Subject: Fuel Leak Case No. RO0002908 and Geotracker Global ID T0600196622, Miller Square Park, 2259 First Street, Livermore, CA 94550

Alameda County Environmental Health (ACEH) staff has reviewed the fuel leak case file for the above referenced site including the recently submitted document entitled, "*Pilot Test Work Plan or Draft Corrective Action Plan*," dated June 10, 2009, which was prepared on behalf of Chevron by Conestoga-Rovers & Associates. Although the document is entitled, "*Pilot Test Work Plan or Draft Corrective Action Plan*," the document does not propose a pilot test or corrective action. Instead, the document is a work plan to install four monitoring wells for the purpose of collecting additional data for one year prior to evaluating remedial options.

Sounding: CPT-01

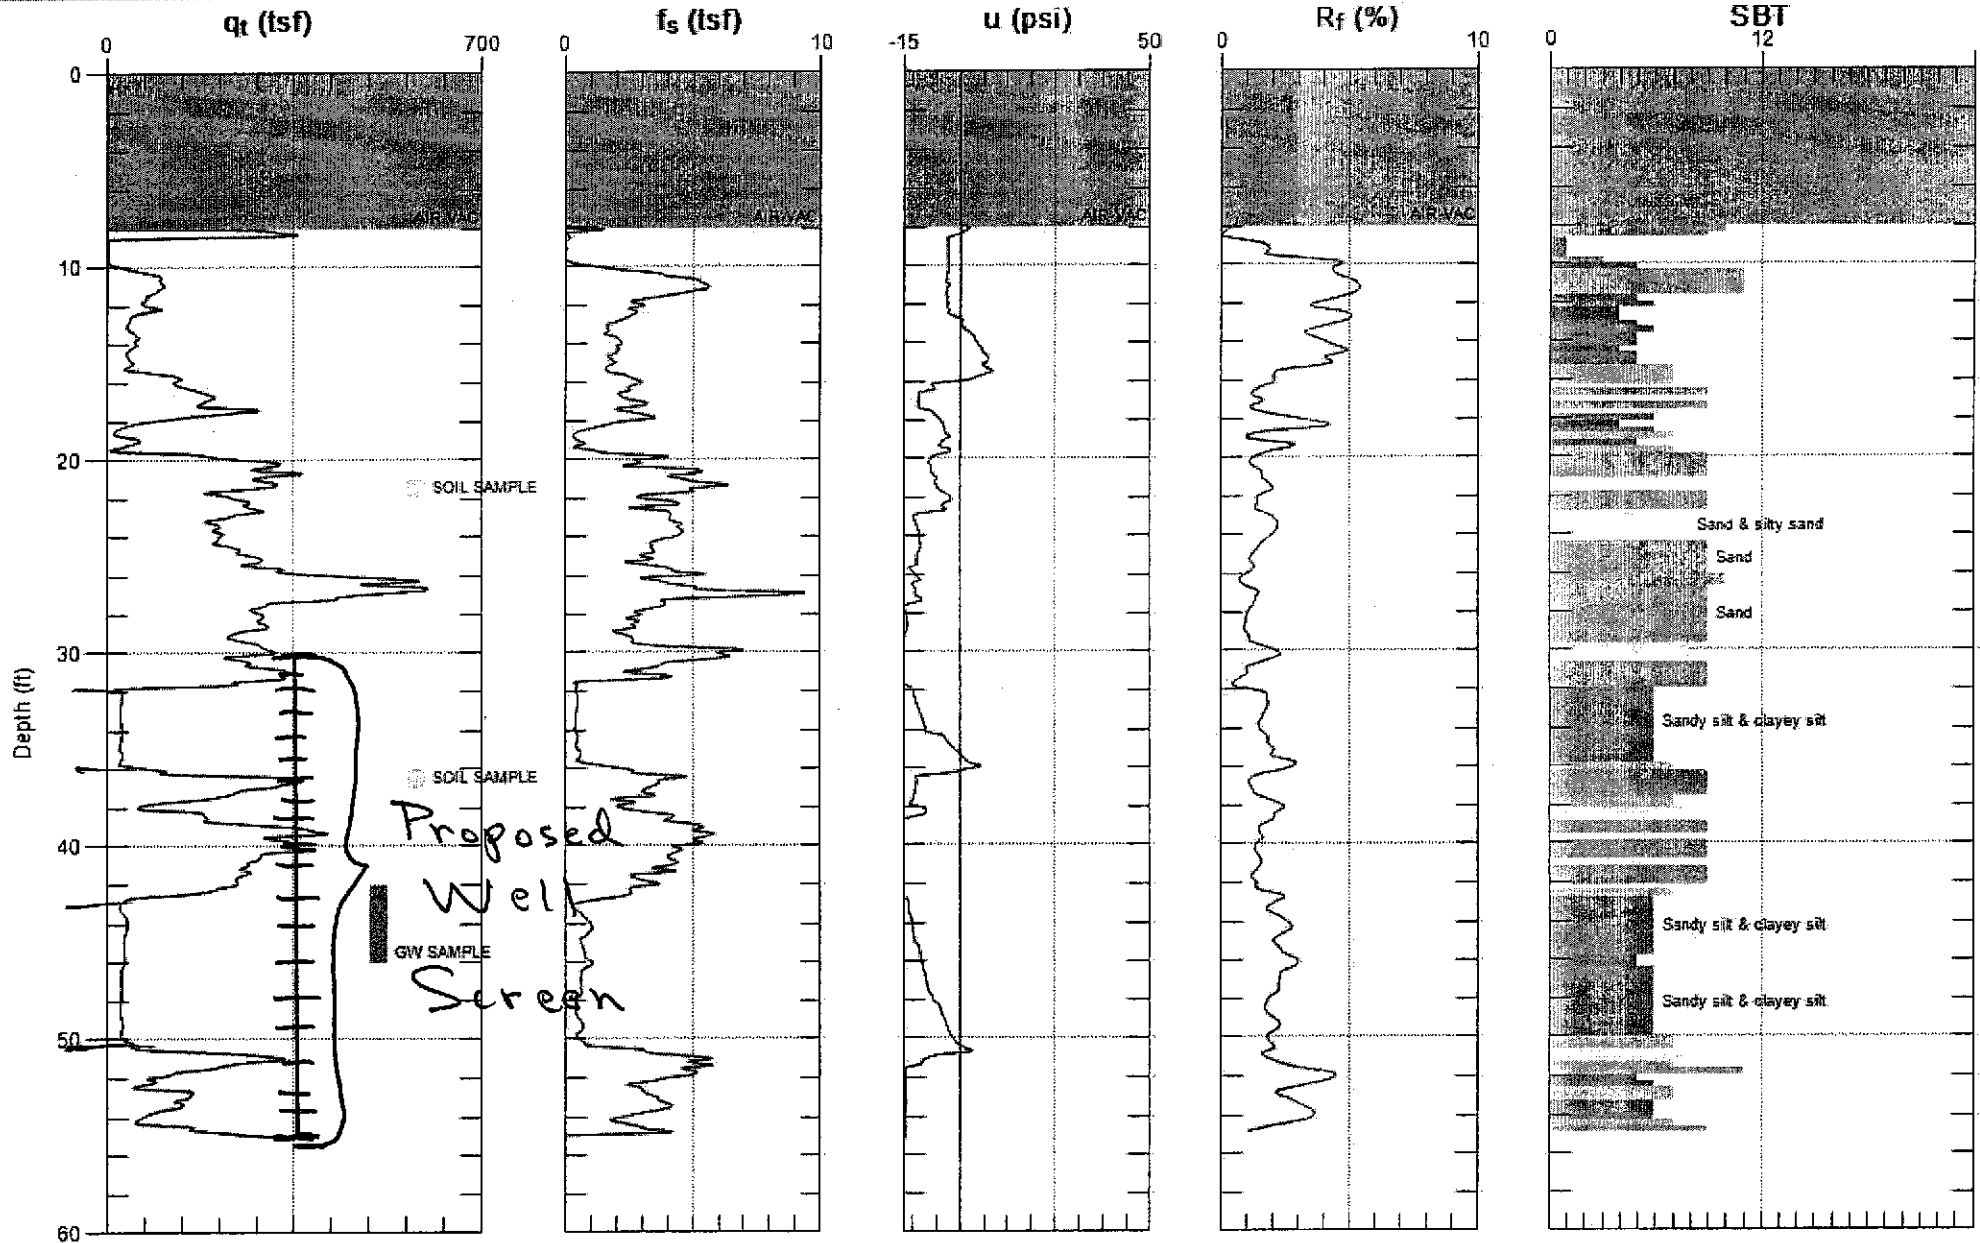
2. **Proposed Well Screen Intervals.** The proposed screen intervals for the four monitoring wells are 30 to 55 feet bgs based on previous depth to first encountered water and variable groundwater elevations at nearby sites. Site hydrogeologic conditions than variable depths to first encountered groundwater must be considered in designing well screen intervals. The well screen intervals must target discrete water bearing layers and not create vertical conduits for ambient well flow. Where necessary, multiple wells must be installed to monitor separate vertical intervals. Since the proposed well locations are adjacent to previous soil borings, the hydrogeologic conditions at the proposed locations are known and must be considered. As one example, we have attached the CPT log for boring CPT-1, which is adjacent to one of the proposed well locations. As shown on Attachment 1, the proposed well screen interval from 30 to 55 feet bgs connects three separate coarse-grained layers that are separated by finer grained layers. A well constructed in this manner at the proposed location would provide a conduit for vertical flow and water levels in the well would be affected by vertical gradients between the difference intervals. Clearly, the proposed well screen interval for a well adjacent to CPT-1 would not be appropriate. A second example of the need to consider the site hydrogeology is shown on Attachment 2, which is the CPT log for boring CPT-5. The proposed well adjacent to CPT-5 would be screened exclusively in the finer-grained soils consisting of silts and clays present between approximately 11 and 55 feet bgs. The proposed well screen would not intersect any permeable water-bearing layers. Therefore, the proposed well at this location would not provide sufficient data on contaminant migration off-site since the well does not intersect the likely pathway for contaminant migration. Please review site hydrogeology and propose screen intervals that are appropriate for the site.
